The Landings, Ford Airfield

Phase RM1(North)

Waste Infrastructure
Technical Note

Report Ref: 2205771-R26

Figure 2: Noise levels due to Operations at the Grundon Site (Application Reference: WSCC/096/13/F and WSCC/027/18/F)

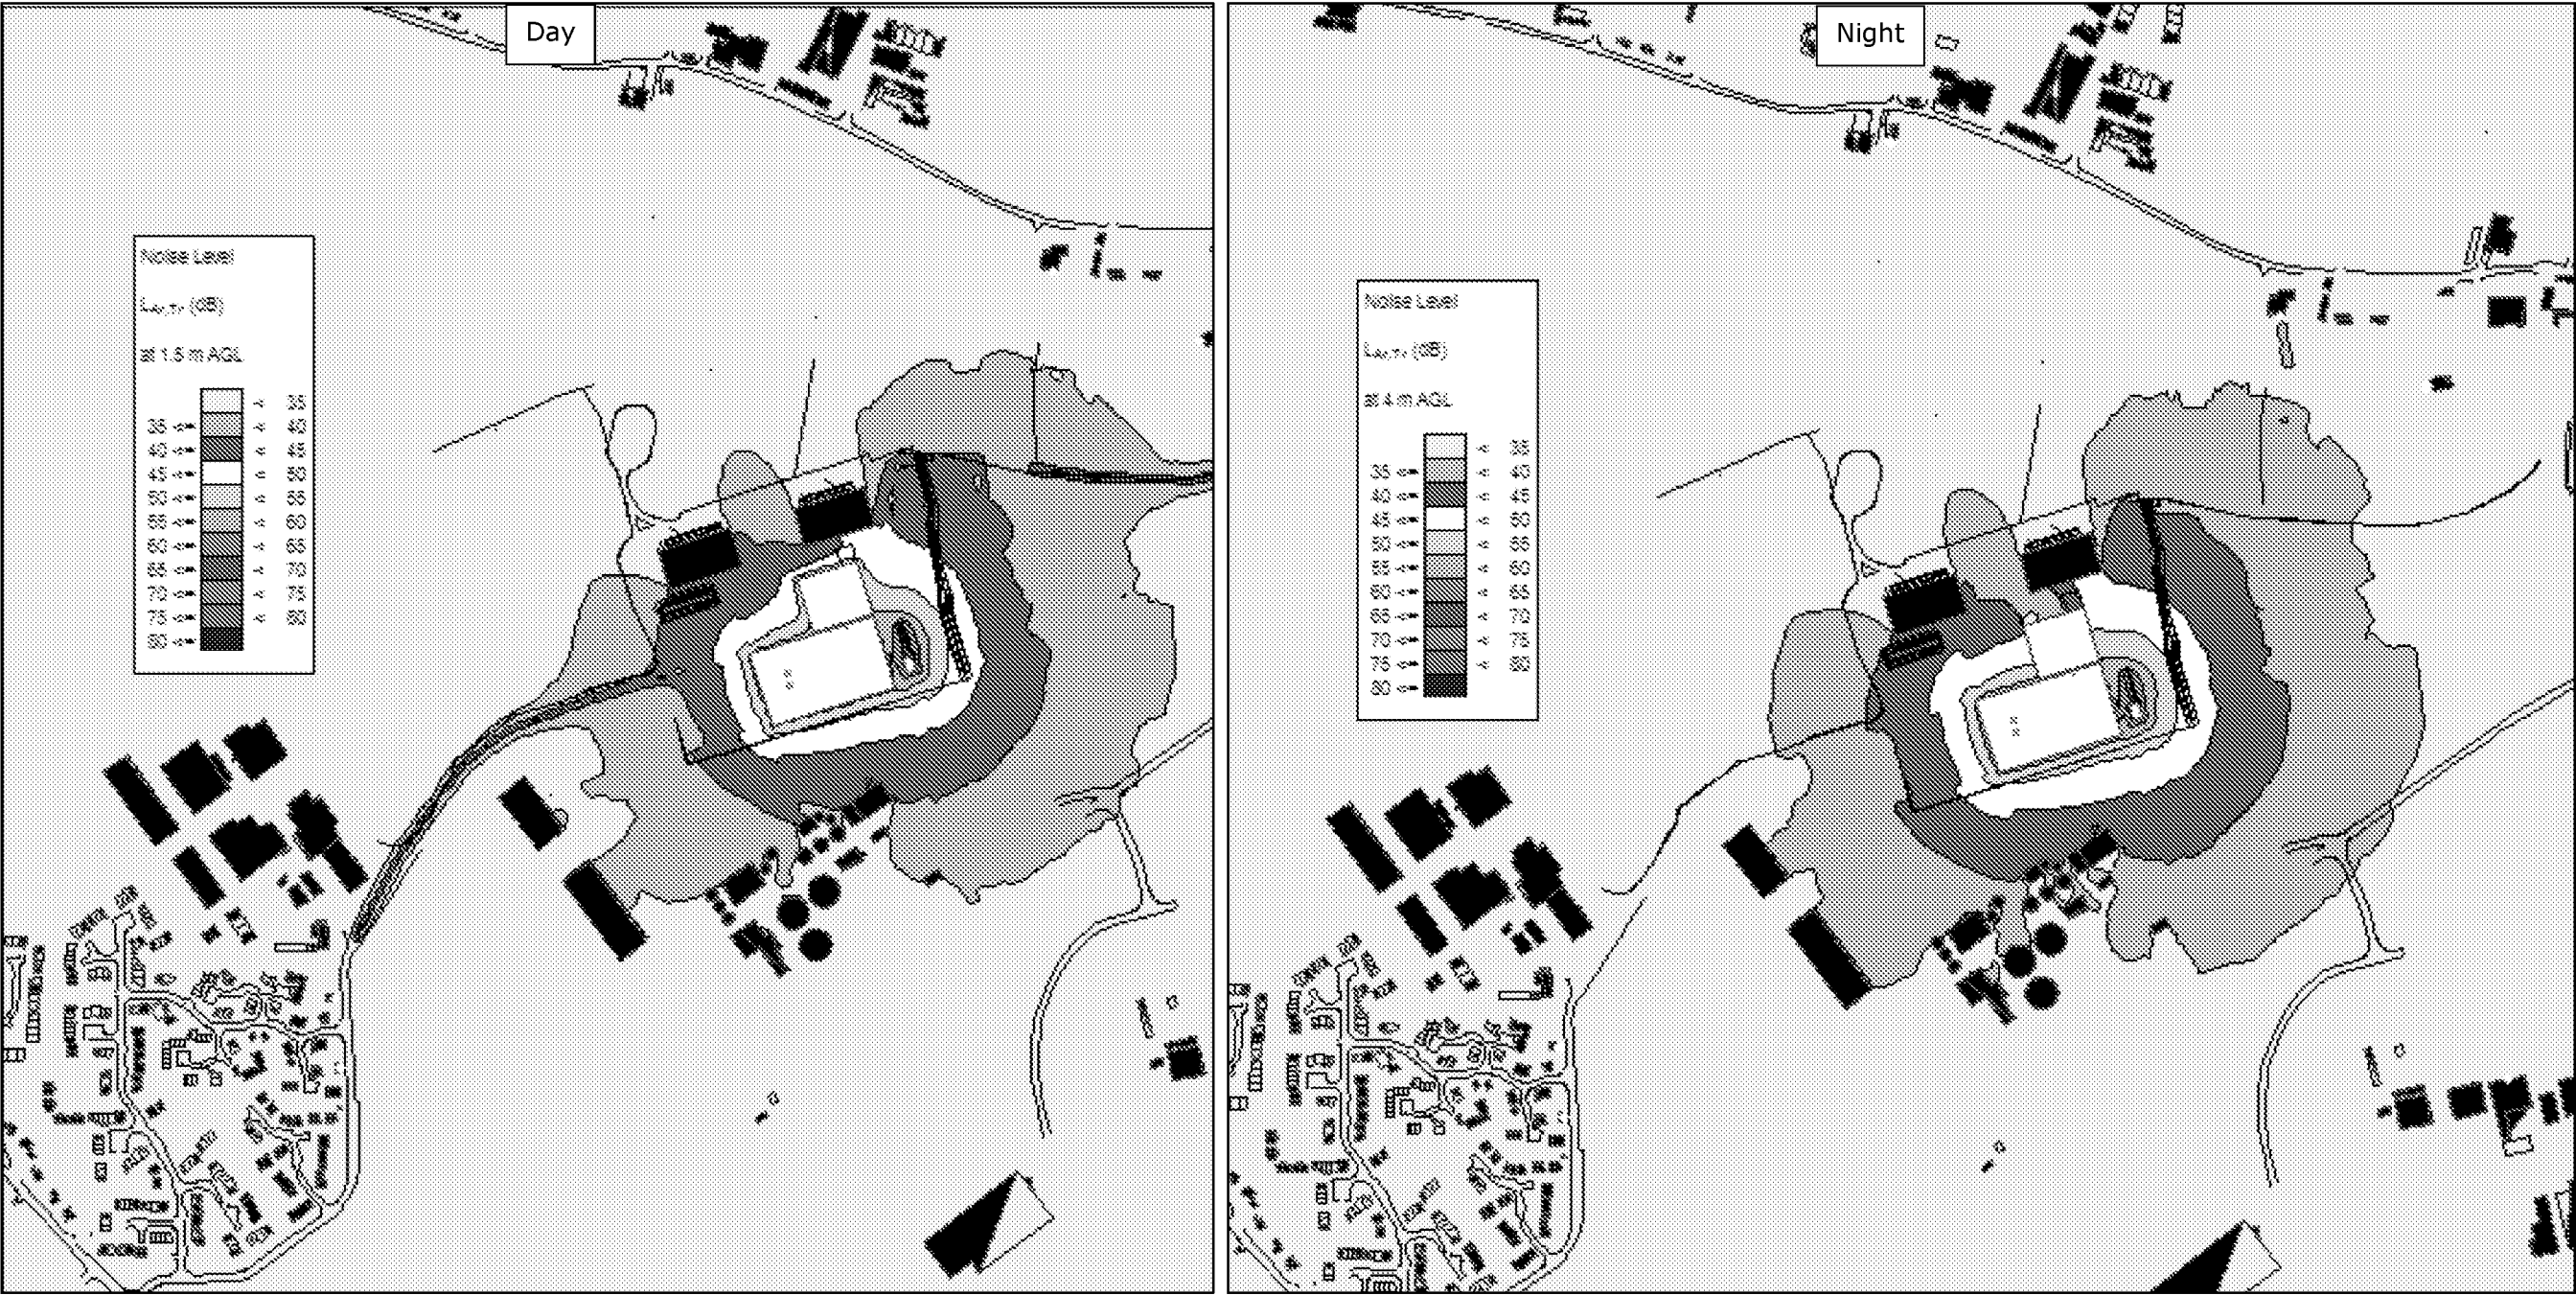
- 2.5. WSCC noted that the noise assessment does not demonstrate that noise from the Circular Technology Park/Grundon Waste Facility (Grundon) will meet the requirements of Condition 28 of the planning application for the facility, i.e., a rating level no greater than 35dB at the nearest sensitive receptors.

- 2.12. The noise assessment which accompanied the planning application for the Grundon Site shows the modelled noise levels with the proposed future operations, an extract from the noise modelling is shown below in Figure 2. Based on the noise modelling, noise levels are predicted to be significantly below 35dB $L_{A_r,Tr}$ at RM1 (North).
